#2024-0257 Wake Robin LLC Special Exception Application

RE: APPLICATION REVIEW - SUPPLEMENTAL

#2024-0257 / Wake Robin LLC & Ms. Serena Granberry
(ARADEV LLC) / 104 & 106 Sharon Road & 53 Wells Hill Road / Special Permit (Section
213.5) / Map 47 / Lot 2 & 2-1 / DOR: 08/05/2024

REMA Job No.: 24-2744-SLS4

FIGURE F: BEDROCK GEOLOGY OF SUBJECT SITE
Wake Robin Inn, Sharon Road and Wells Hill Road, Salisbury, CT

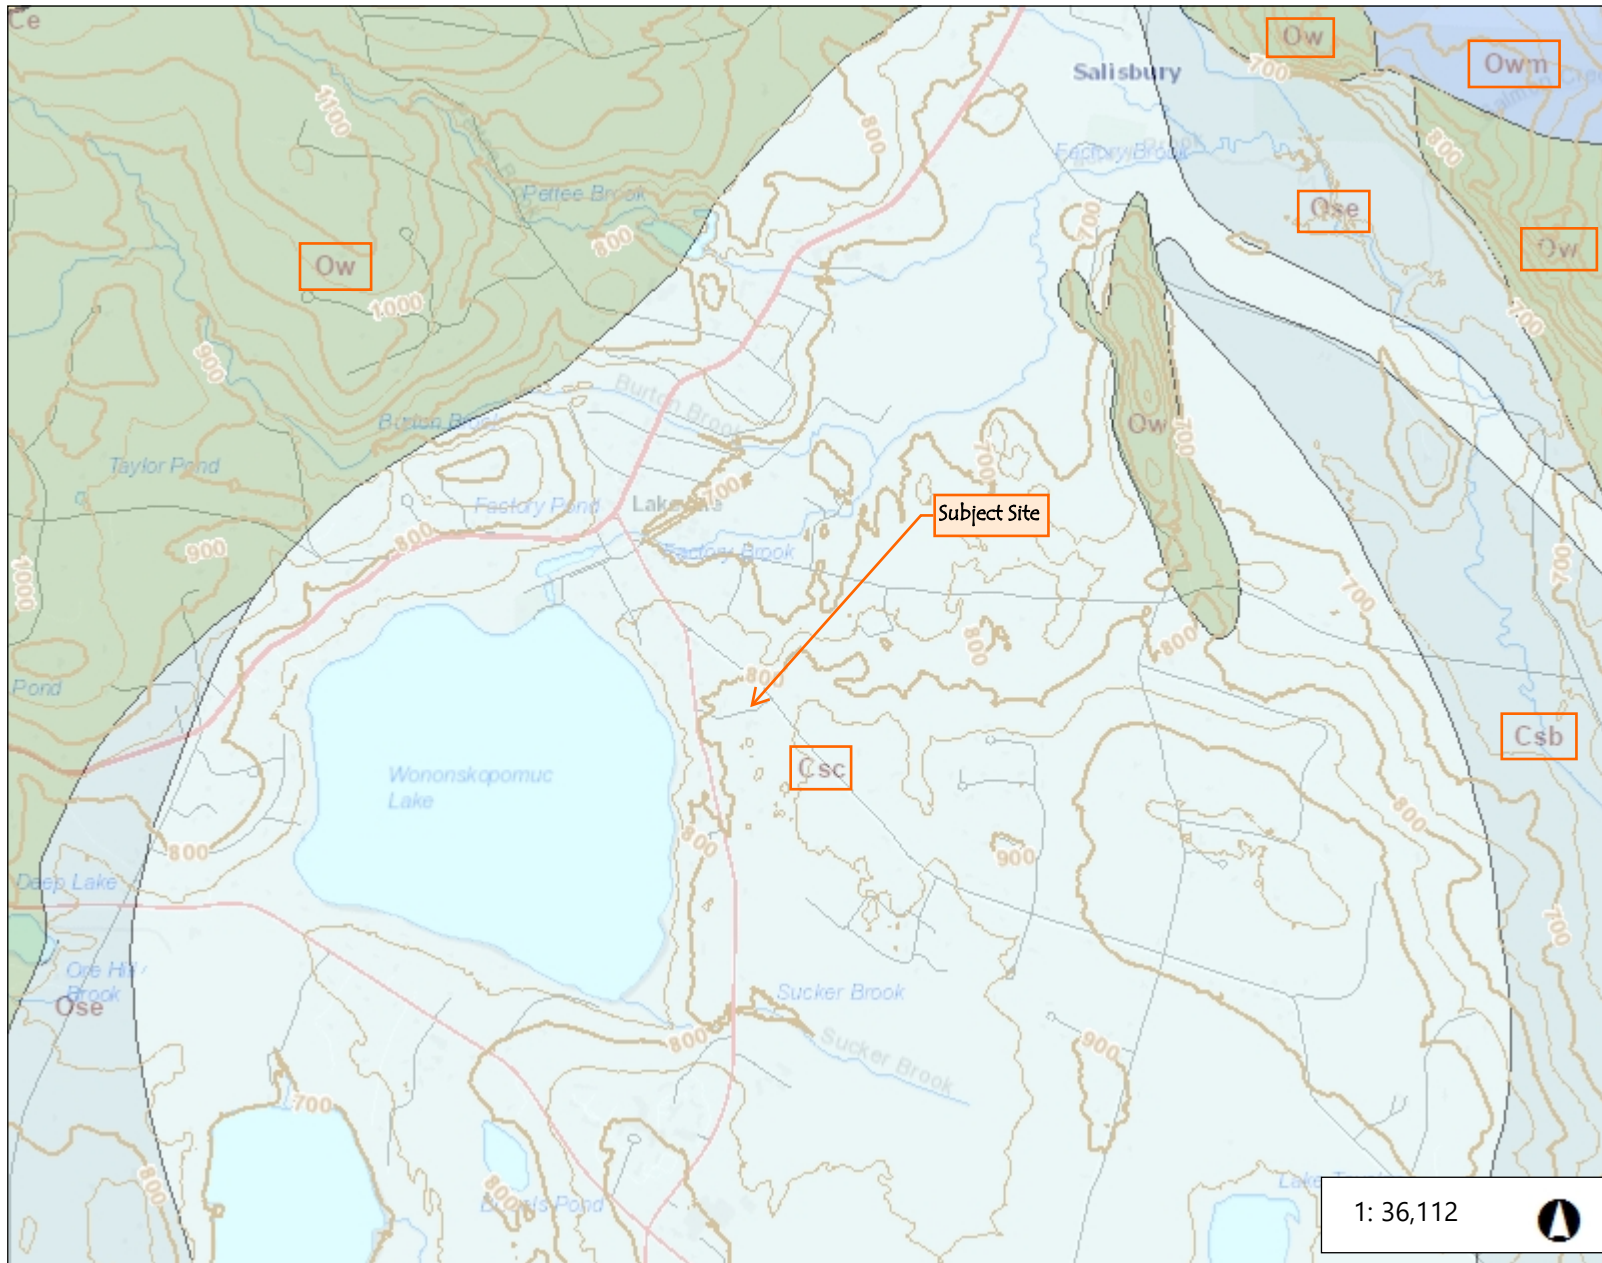
The SLR Soil Scientist report does not mention the unusual bedrock geology of the site. They provide a list and map of the soil series on the site, but they are not described, and their ecological significance is not explained. The bedrock under this site is a large area of Stockbridge marble with several contiguous units (Csc, Csb, Ose) (see Figure F, attached). Marble is metamorphosed limestone and occurs only in the far western portion of Connecticut, often just a narrow, north-south oriented band. Glacial till deposited on the site also includes fragments from bedrock to the north and north (Walloomsac schist, Unit OW unit) that also weathers into relatively mineral-rich soil.
